ENTERGY NUCLEAR OPERATIONS, INC.
JAMES A. FITZPATRICK NUCLEAR POWER PLANT
DOCUMENTS AND VENDOR PROCEDURES

OFFSITE DOSE CALCULATION MANUAL
DVP-01.02
REVISION 9

Rev. CHANGE AND REASON FOR CHANGE

FIGURE F-5
JAMES A. FITZPATRICK NUCLEAR POWER PLANT
OFFSITE DOSE CALCULATION MANUAL (ODCM)
LIQUID EFFLUENT RELEASE PATHS

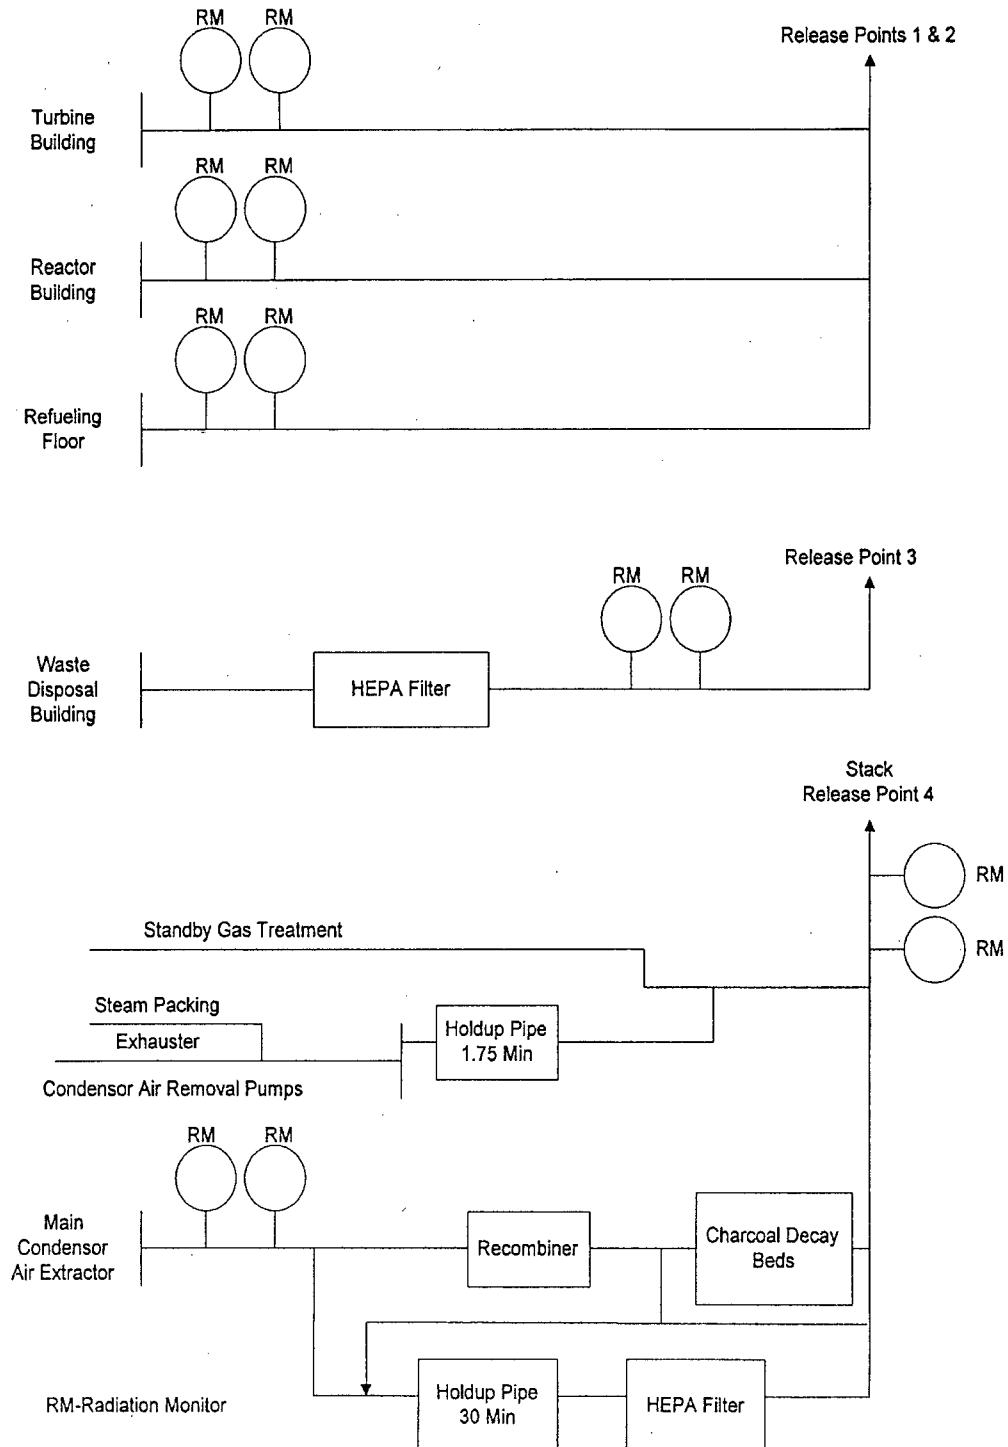
19. Part II, Appendix F, Page F-10, Figure F-5

Revised Figure F-5, Liquid Effluent Release Pathways to include the East and West Storm Drains and the associated inputs.

Reason: This change increases the accuracy of the ODCM by identifying potential and existing liquid effluent pathways. Tritium has been identified as an effluent in the West Storm Drain (CR-2002-03695, CA-0013).
